Declaration of HW change on peiker module series V1140

HW Change 01/2014: Change of LPDDR SDRAM memory

Fig. 1: Left side module uses Micron MT46H64M32LFCM-5 IT:A. Right side module with Micron MT46H64M32LFBQ-48 IT:C is decreased in y-size of the package because of smaller silicon die inside, compared to left module with old memory

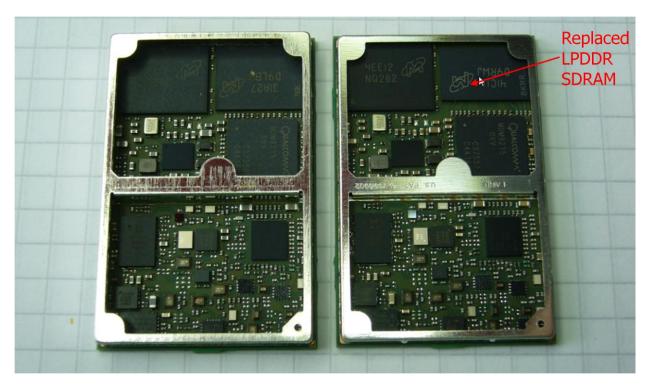
The Mobile LPDDR SDRAM memory used in the V1140 module series becomes end of life. Therefore, peiker will replace the memory without any layout or software change by a memory type distributed by the same vendor. In detail peiker will change part from "Micron MT46H64M32LFCM-5 IT:A" to "Micron MT46H64M32LFBQ-48 IT:C".

The new memory device is fully function and pin compatible and uses the same bus timing and memory organization. The vendor's change is just a die shrink. The old memory was produced in 50nm technology and the new part is produced in 30nm technology. The technology of silicon die packaging is unchanged, but decreased in y-size. Electrical and timing parameters in both datasheets are identical. The documents with characterization data delivered by manufacturer are attached.
